Development Review Committee

Re: <u>Trailside Townhomes – Site Plan and Plat Amendment Request</u>

Application No.:	SPR-58-2022 and SUBD-111-2022
Applicant:	John Wheatley, representing IKON Development
Project Location:	2142 East Brookings Dr.
Current Zoning:	RR-22 (Rural Residential), RR-43 (Rural Residential), and RM (Multi-
	family) Zone
Acreage:	19.37 Acres (Approximately 843,757 ft ²)
Request:	Request for approval of a Site Plan and Plat Amendment in the
	RR-22 and RR-43 zones in order to develop the vacant property
	with 152 townhomes.

sheet **C2. I**

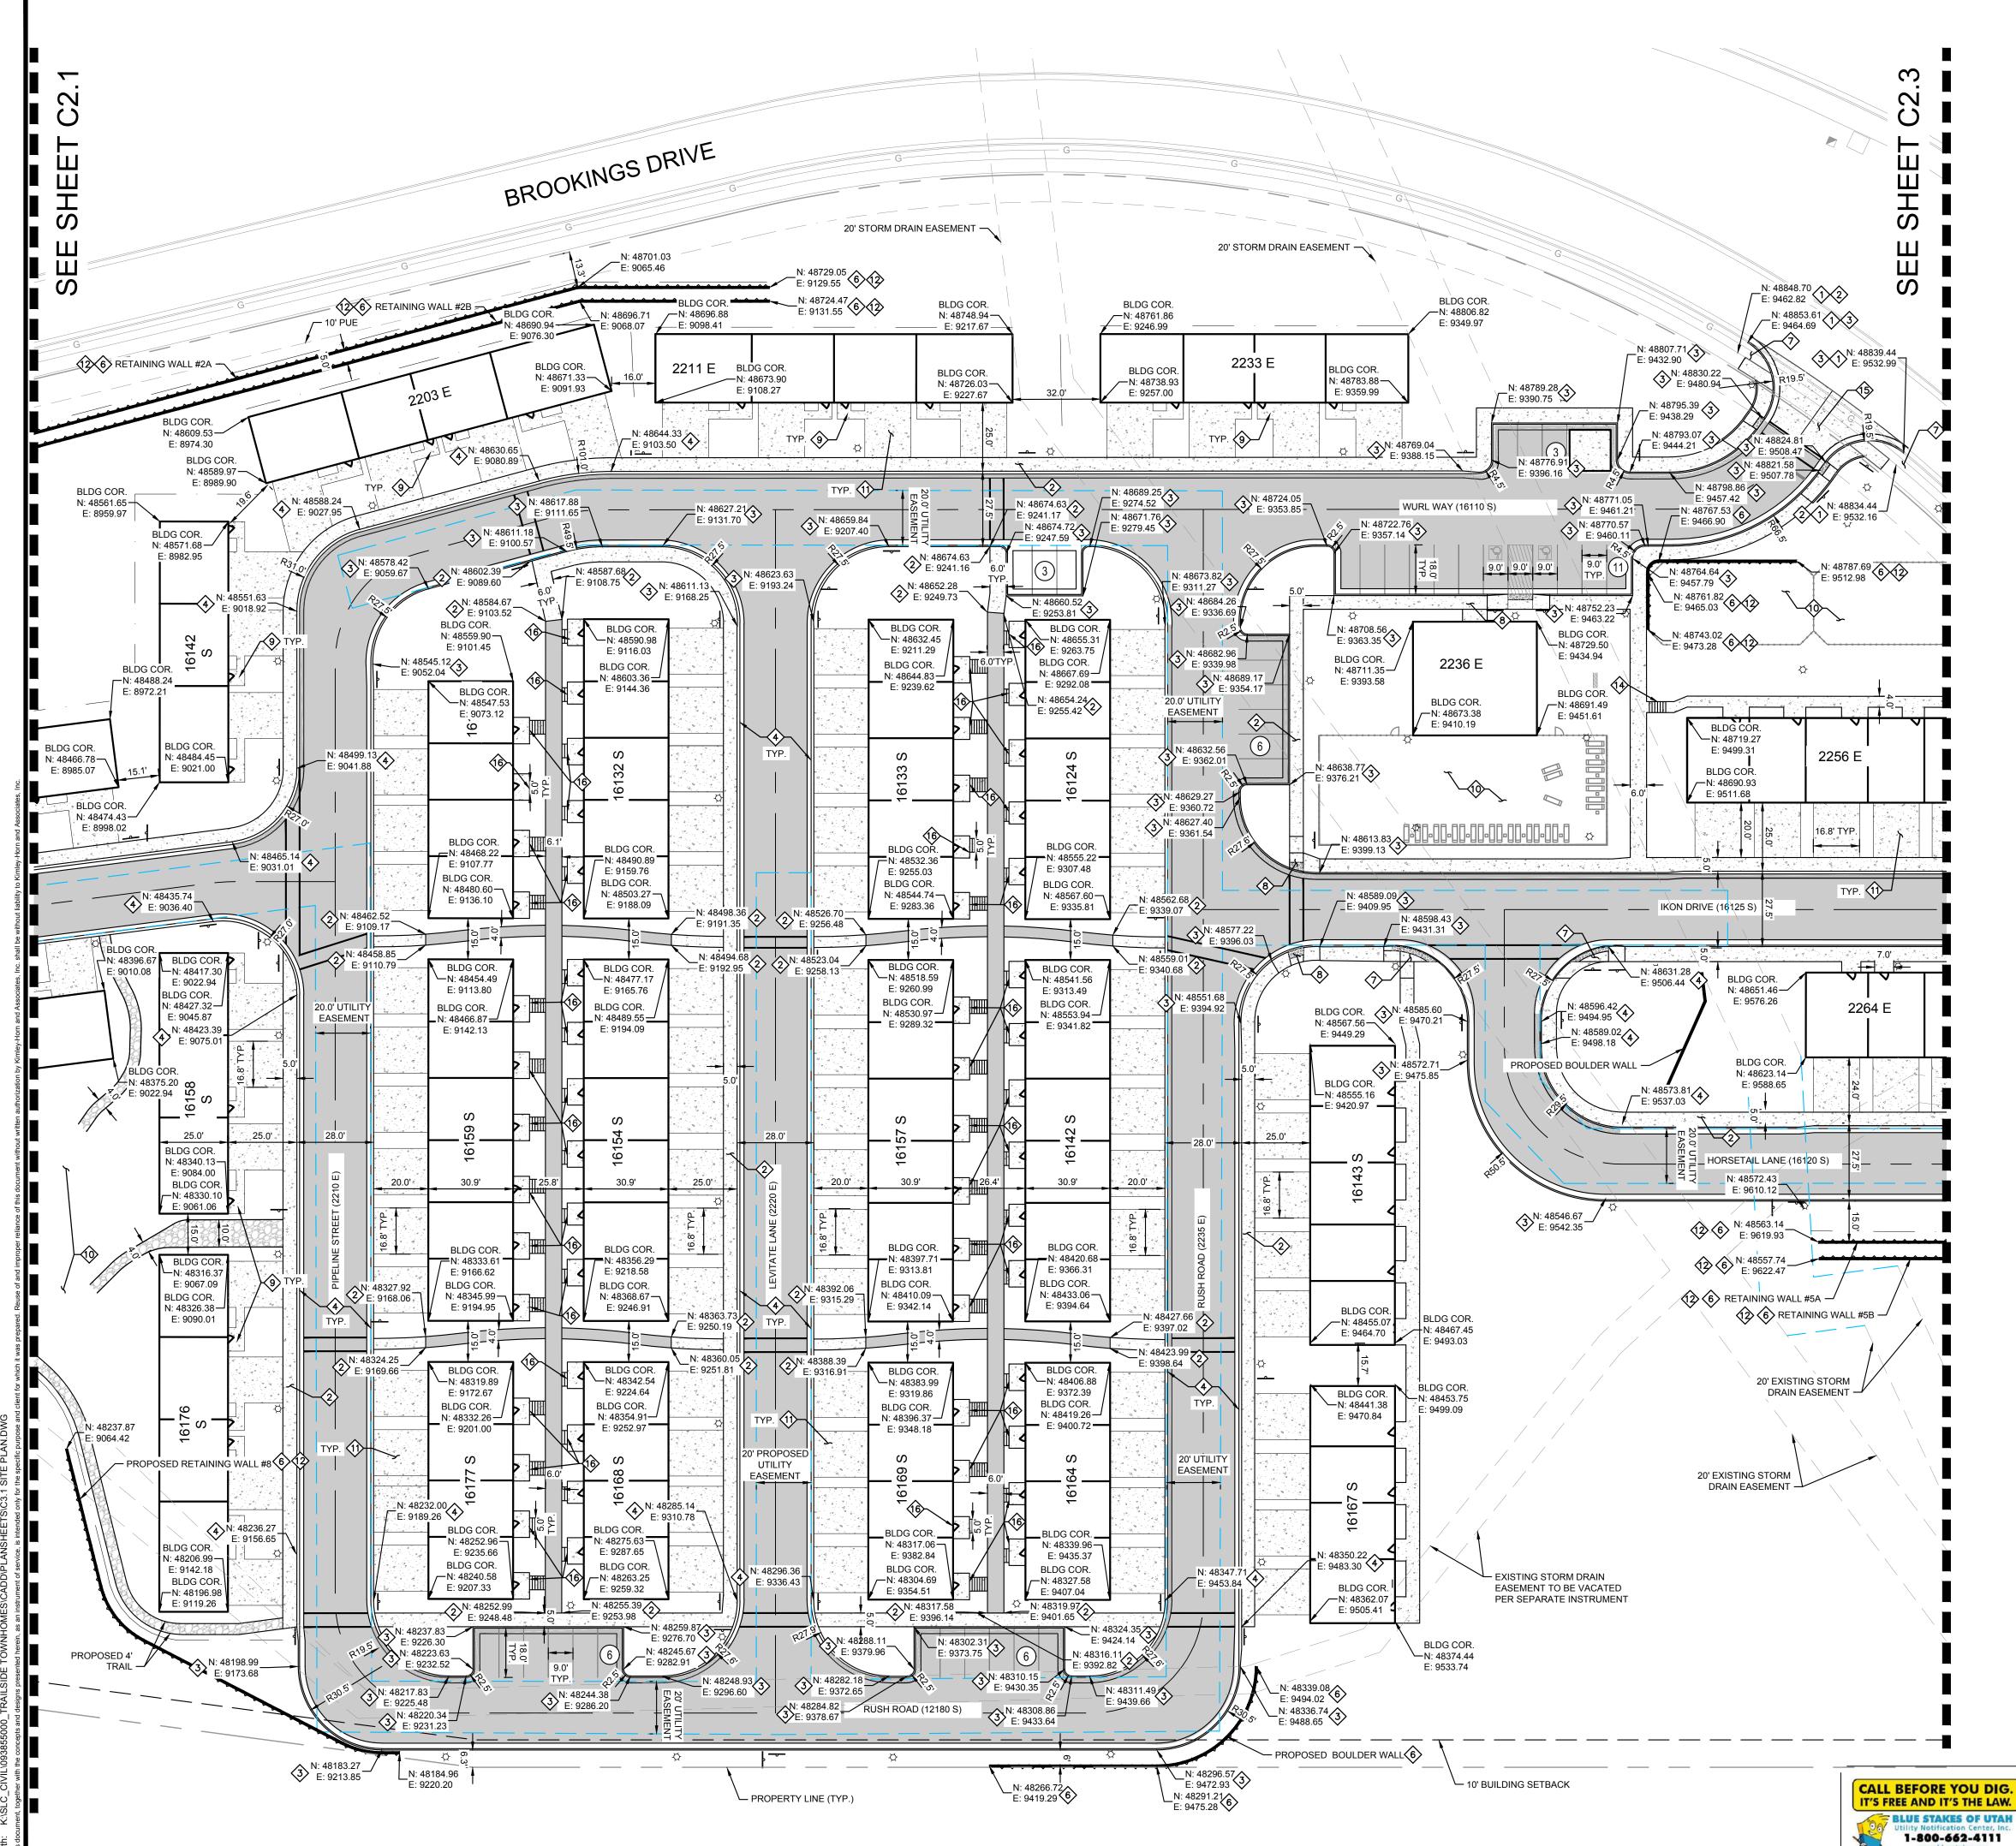
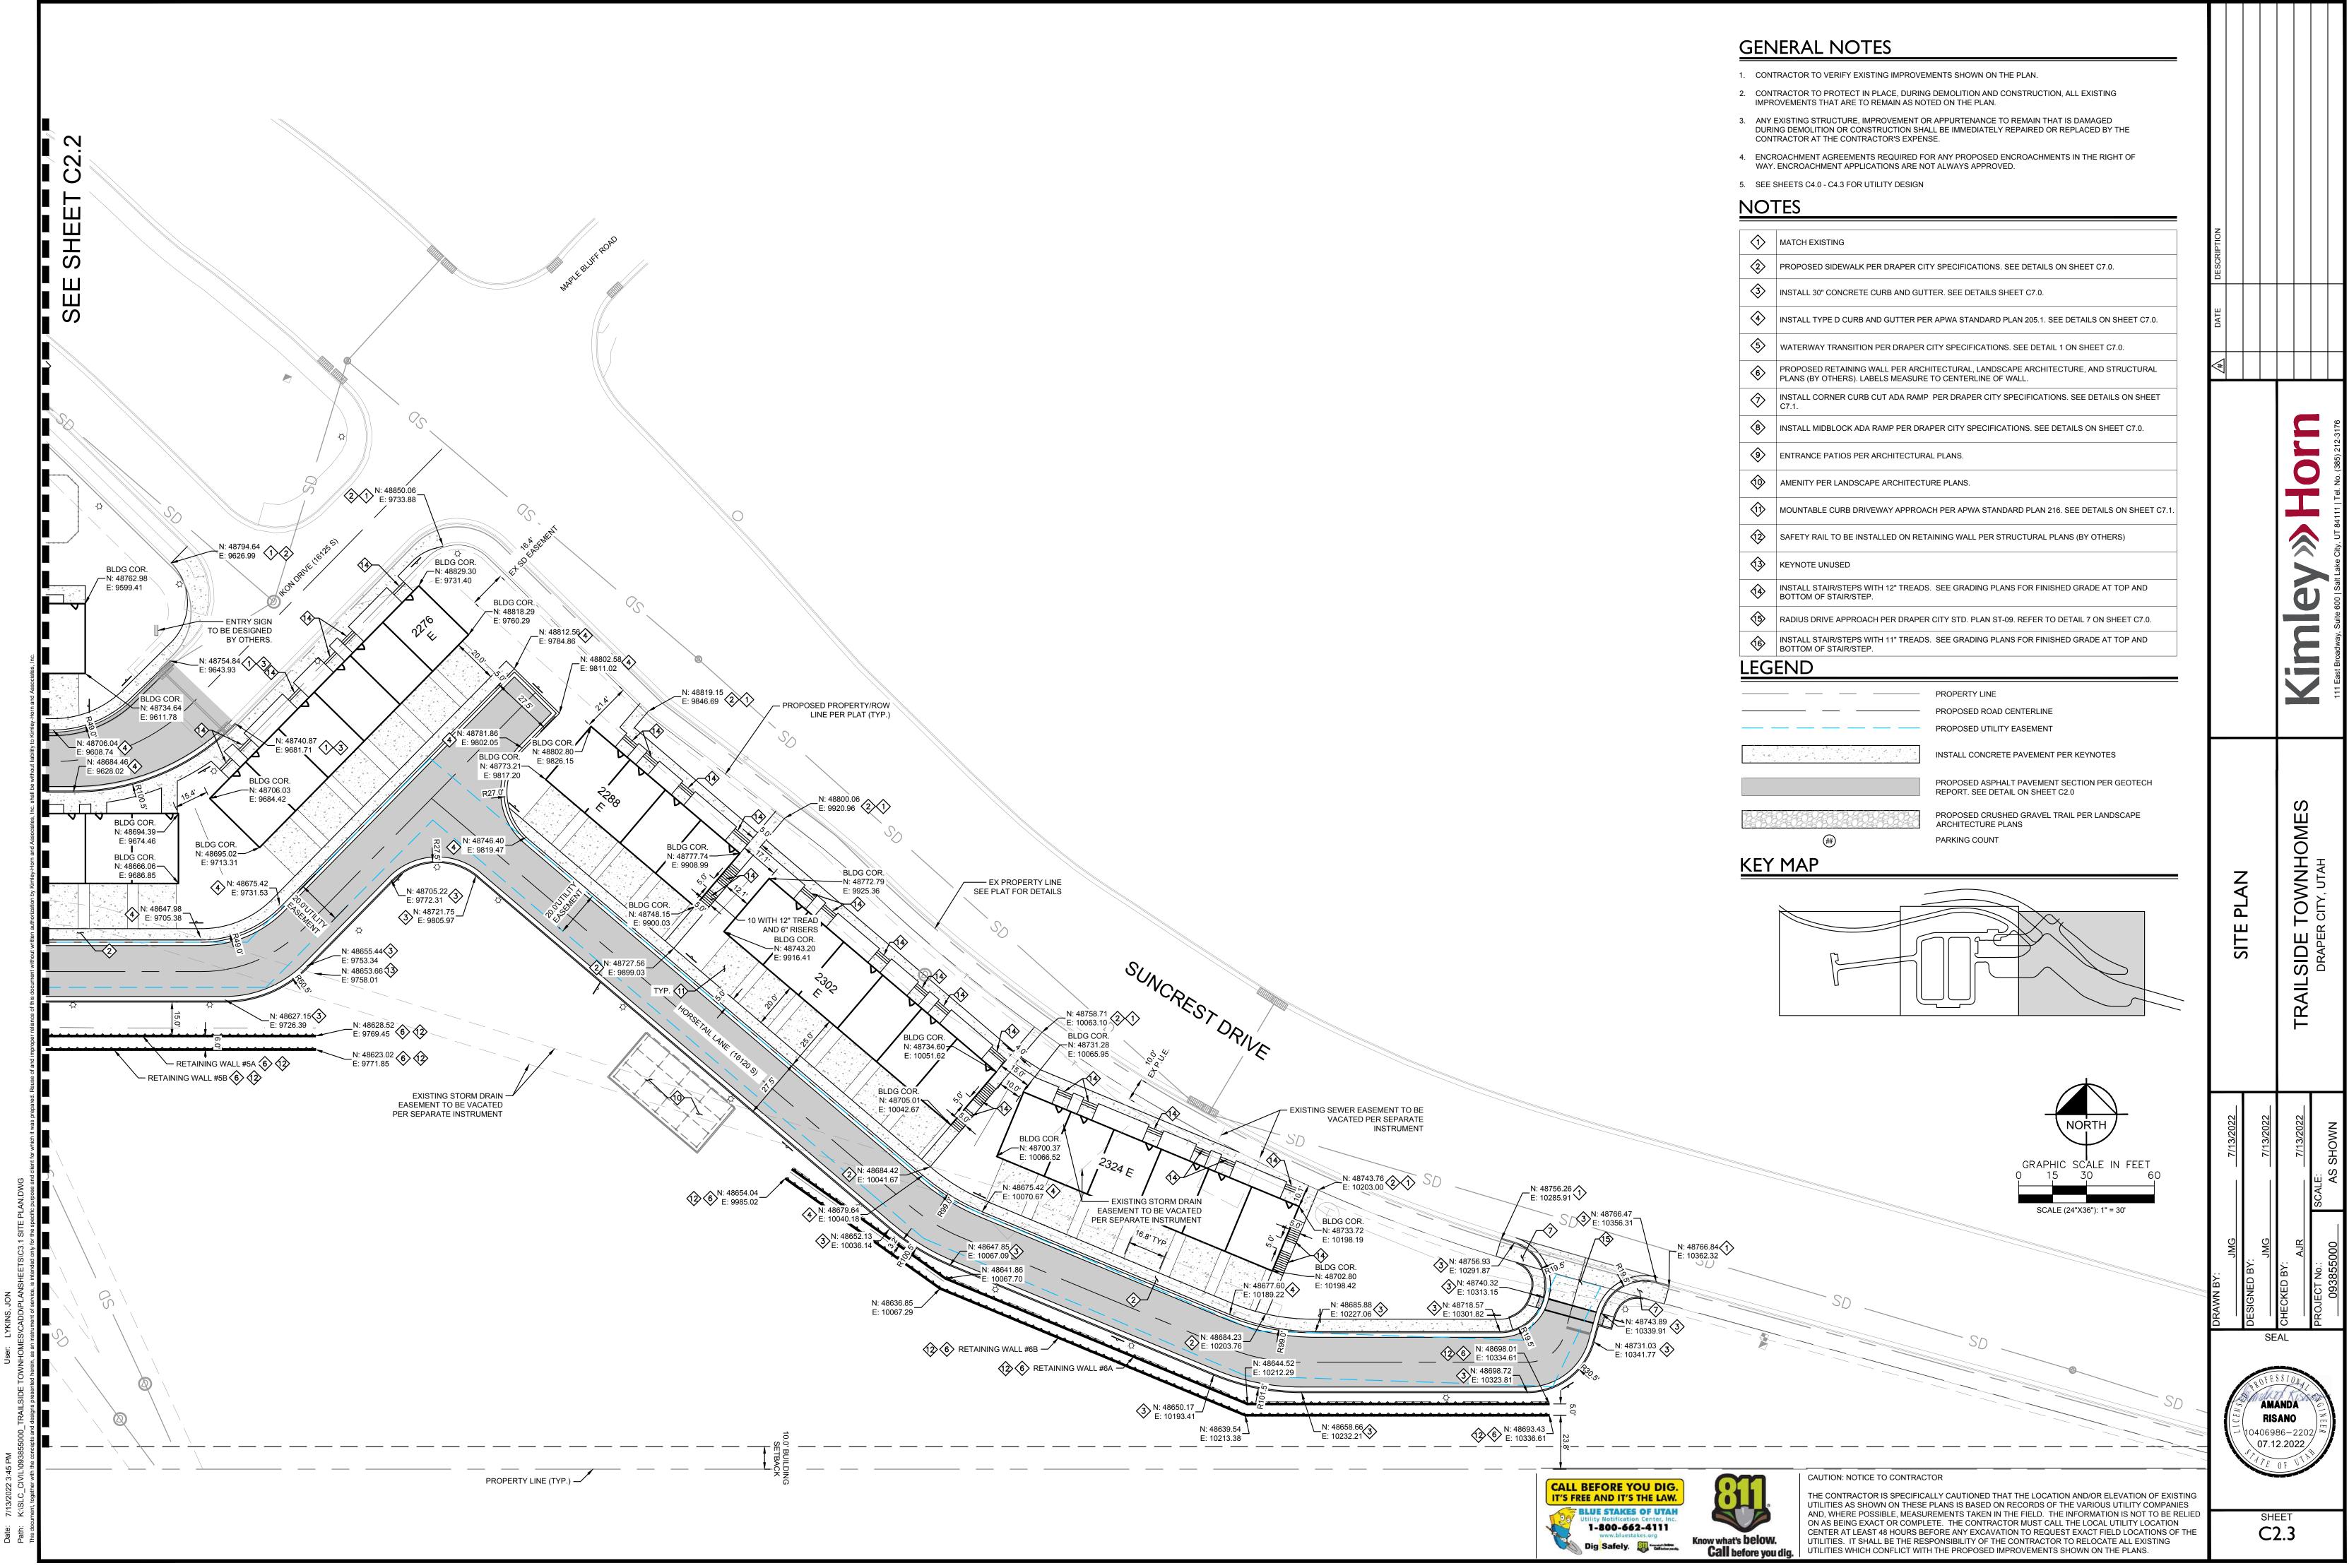
Site Plan Layout. The property will be developed with 32 townhome buildings equaling 152 dwelling units (Exhibit F). The site will be accessed from Brookings Dr. and Suncrest Dr. There will three ingress and egress points in total.

Boundary Line Setback-			
Front	Min 5-feet to Max 20- feet	10-feet	
Front	Min 5-feet to Max 20- feet	17-feet	
Rear	10-feet Min	61-feet	
Rear	10-feet Min	178-feet	
Driveway Depth	20-feet Min	19-feet	Changes required

<u>Circulation</u>. The applicant is proposing private roads (Exhibit J). Dwelling units will be a mix of alley loaded and front loaded structures depending on their location in relation to areas with large ground slopes. The center of the development will have a grid system with alley loaded units and a center walkway running between the front of the units. A western single road spur will serve front loaded units on either side of the street. Two eastern spurs will serve units on one side of the road. These units will be alley loaded.

Stub Street Connections	Required to connect to all stub streets	The property will have direct connection to the Brookings Dr. stub	There is not a requirement to continue the public roadway through the property.
# of Cul-de-sacs	NA	1	
Street Width	26-feet Min	26-feet to 28-feet	
Street Ownership	Private		
Sidewalks	Sidewalks required on both sides of the street	Sidewalks on one side of the street	Deviation requested

The applicant has submitted a request outlining how they believe they have complied with the deviation standards (Exhibit K). The applicant states that the development will have a mountain ambiance and use reduced hardscapes and narrower rights-of-way similar to what is seen in the nearby Suncrest development. The applicant also discussed the restriction on usable space for the development based on the grading and slopes on the property. Staff has reviewed the sidewalk design. There are two buildings that won't have a sidewalk running in front of them. They will have access to pedestrian trails at the ends of the roadway. All other units have ample pedestrian access.

<u>*Parking*</u>. The applicant is providing two car garages for each unit, along with a two car driveway (Exhibit F). Guest parking is provided around the club house area and on the west side of the development.

- A. Show driveway dimensions for all buildings.
 - B. All driveway shall be at least 20-feet deep, not including the sidewalk.
- 4. Prior to Land Disturbance Permit issuance, amend the architectural plans to address all outstanding comments:
